Docket Item # 5 & 6  
BAR CASE # 2011-0128 & 0129

BAR Meeting  
June 15, 2011

**ISSUE:** Permit to Demolish/Encapsulate &  
Certificate of Appropriateness (Addition & Alterations)

**LOCATION:** 910 South Fairfax Street

Figure 4: Existing/Proposed Attic Plans

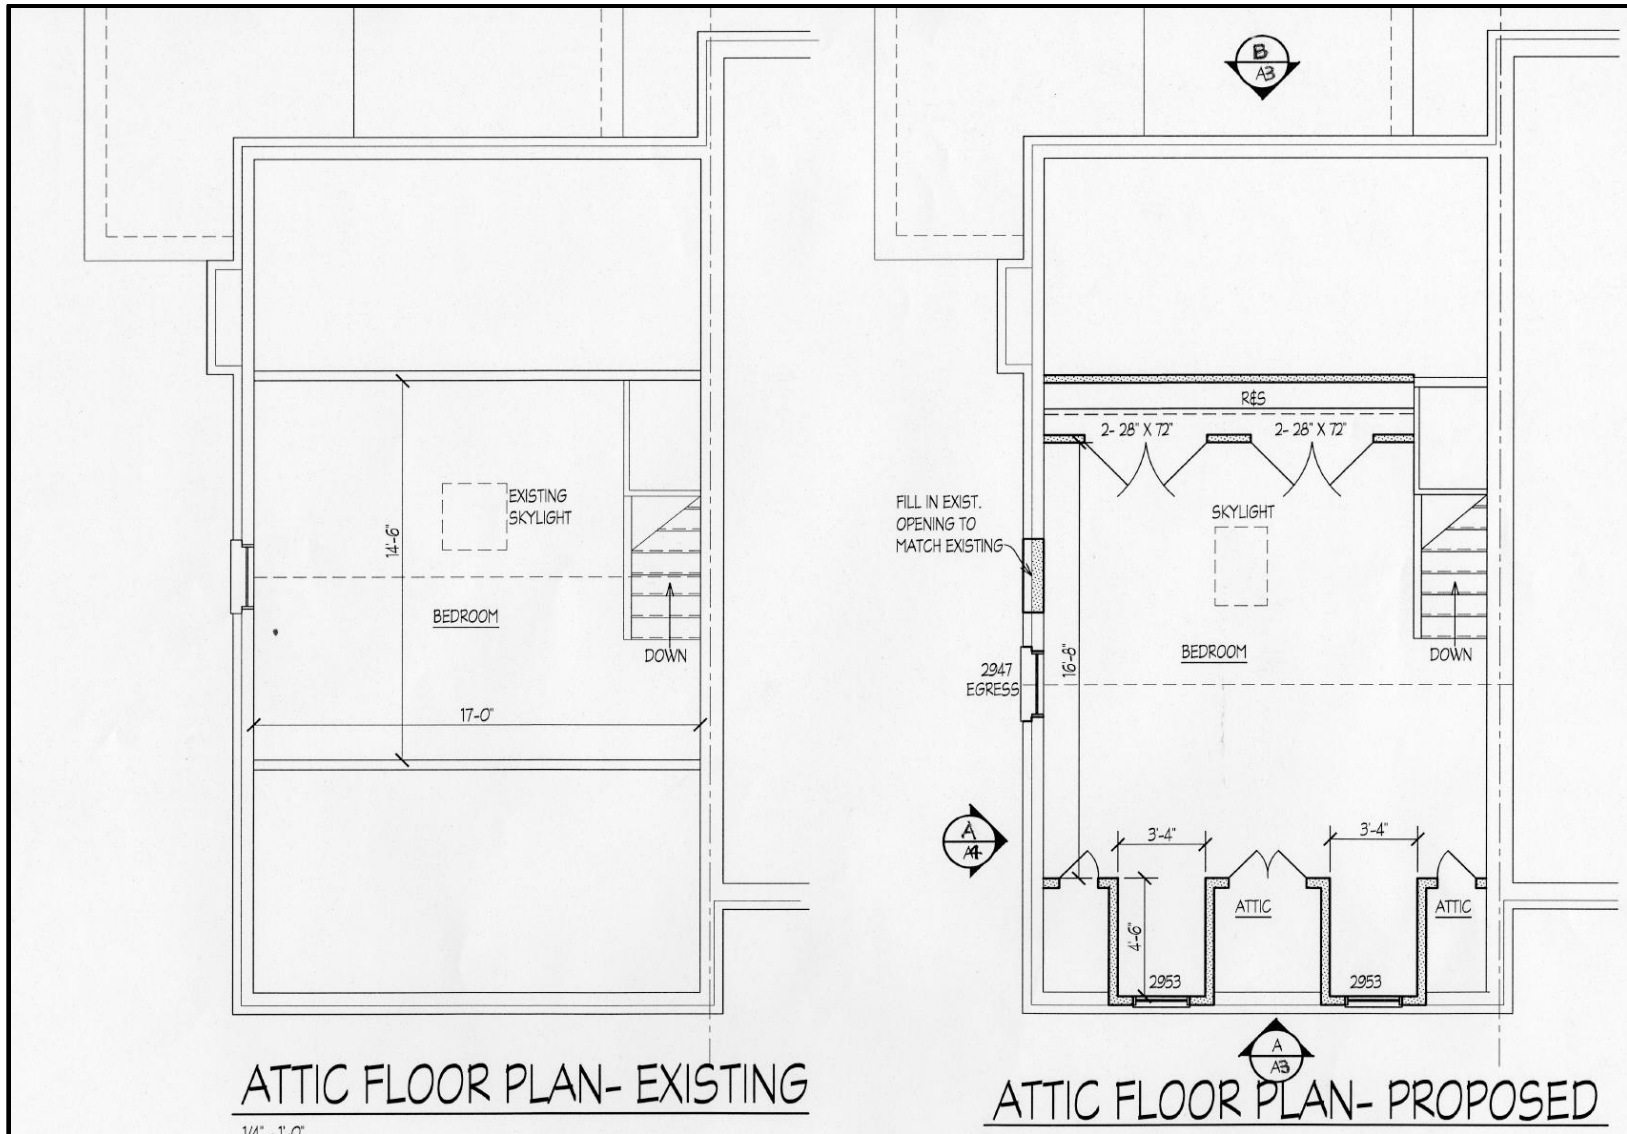
C-6 Provide details of mechanical equipment located in the attic

Figure 5: Proposed Section/Details

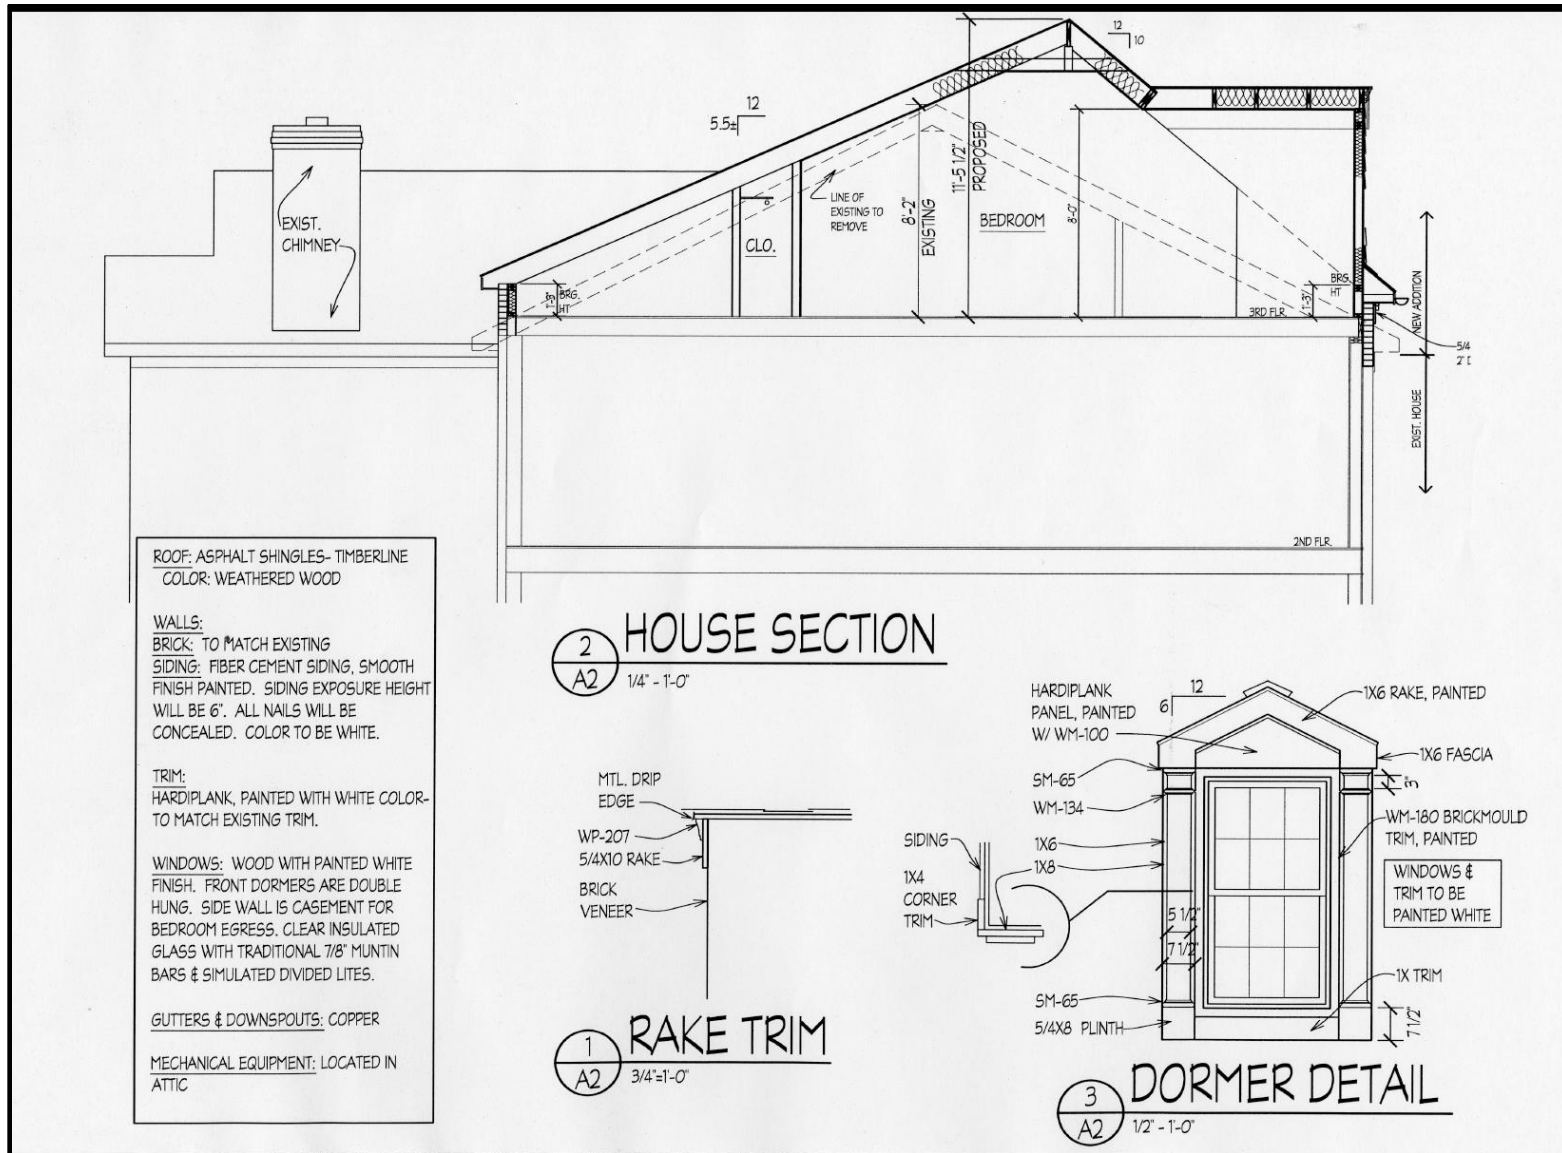
C-4 Plans shall include framing details of rafters, ridge, collar ties, and dormers.
